STATE OF NEW HAMPSHIRE INTER-DEPARTMENT COMMUNICATION

SUBJECT **Permit Amendment Request**
Walpole-Charlestown, 14747
(DES#2017-01302)

Forwarded herewith is a permit amendment request prepared by NH DOT for the Walpole-Charlestown 14747, (DES #2017-01302) project. The proposed work includes reconstructing three miles of NH 12 located between the Connecticut River to the west of the road and the New England Central Railroad (NECR) to the east to improve safety through this corridor. NHDOT is requesting an amendment due to a design change identified during construction.

2121+27

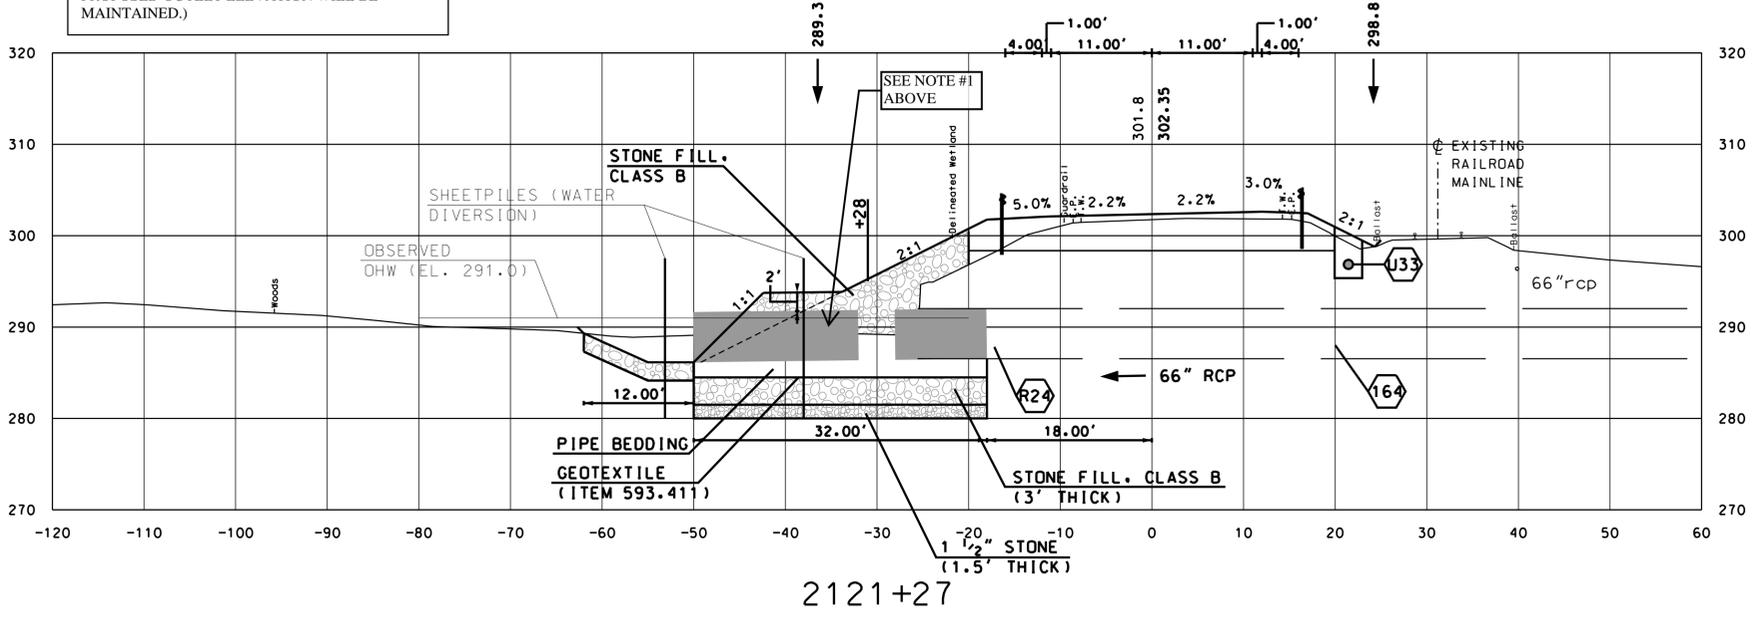
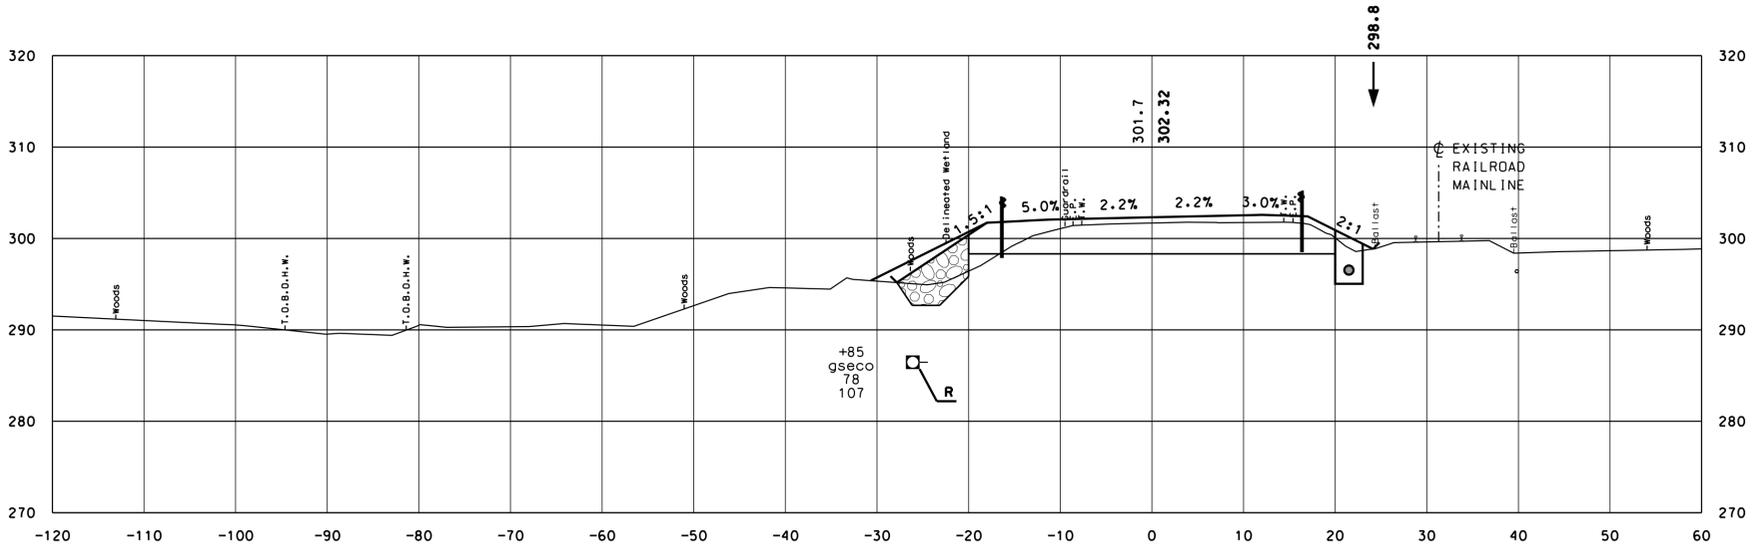
While preparing to replace the 66" RCP at station 2121+27 in-kind and constructing a new outlet headwall the contractor identified that the soils were not suitable to support the installation of a new headwall. Therefore, NHDOT and the contractor are proposing to extend the 66" cross pipe by 19'. The pipe segments under the road will be replaced in-kind with 66" RCP; the last two sections of culvert (the extension) will be 72" RCP. The supplier of the 66" RCP went out of business and the contractor could only find 72" RCP available. By extending the pipe out to the toe of slope, the contractor can construct a more gradual slope (2:1) and eliminate the need for a headwall. Included herewith is a revised impact sheet (sheet 16) and cross section that reflect the pipe extension design change and the elimination of the headwall.

NOTE 1:
 CONSTRUCT 66" RCP FROM 18' LT TO 34' LT
 CONSTRUCT 72" RCP FROM 34' LT TO 50' LT
 CONNECT PIPES WITH CONCRETE COLLAR

(REVISION TO PIPE DIAMETER IS A RESULT OF
 THE LACK OF AVAILABILITY OF 66" RCP.
 PROPOSED OUTLET ELEVATION WILL BE
 MAINTAINED.)

The concept of extending the pipe to the toe of a 2:1 (approx. 50' LT) to El 286.15 and keeping the extent of the stone the same, the apron would be reduced from 31' long to 12' long appears to be a sound solution. This culvert acts as an equalization pipe and the sediment accumulation in the existing pipe confirm the low velocities anticipated. The stream profile downstream rises above the 66" invert out causing ponding and reducing the possibility of high velocities. Scour is not anticipated to be an issue.
